NOTICE for New Tajima Owners

Tajima has recently made a running change to the diameter of the hole in the presser feet on **some** machines. It was 3mm and has now been reduced to 2mm, which is smaller than the diameter of the shank on the RhAT tools (both the Original and the Universal). The current replacement part for the new presser feet is the old part with the 3mm hole.

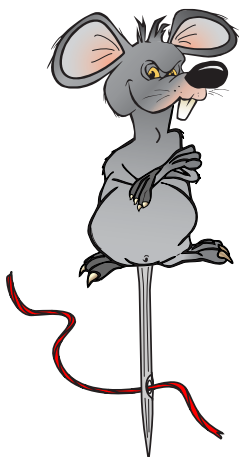
To use the RhAT tools, the hole in the presser foot needs to be larger than .105" diameter, the same size as many of the plastic ink cartridges in a cheap ball point pen.

If you want to use the RhAT tool on these machines, you can replace one presser foot on each head (typically on needle #1) with the old style. Or you could enlarge the hole in one of your presser feet, but care needs to be used to avoid any burrs or sharp edges that could cause damage to apparel.
